From: [Alexander Harding](#)
To: [Transportation Commission](#)
Cc: [Canton, Aaron](#)
Subject: Item 8: Hammersley Rd crossing offset geometry
Date: Tuesday, February 22, 2022 8:35:13 AM
Attachments: [PastedGraphic-1.png](#)
[PastedGraphic-3.tiff](#)
[PastedGraphic-6.tiff](#)
[PastedGraphic-2.tiff](#)

Exhibit 13: Offset sidepath crossing geometry

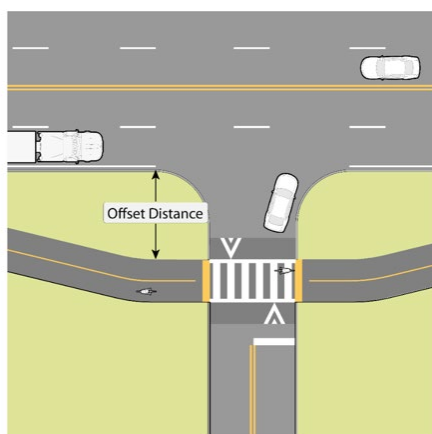
Please consider providing a crossing offset of Gilbert Rd and Whitney Way of **at least 6 feet, preferably more if possible (instead of 5 feet proposed)**. A 6-16.5ft offset is needed for multiuse paths parallel to the roadway according to the Michigan and Minnesota state DOTs. It is crucial for safety and visibility of turning cars. Please see attached figures.
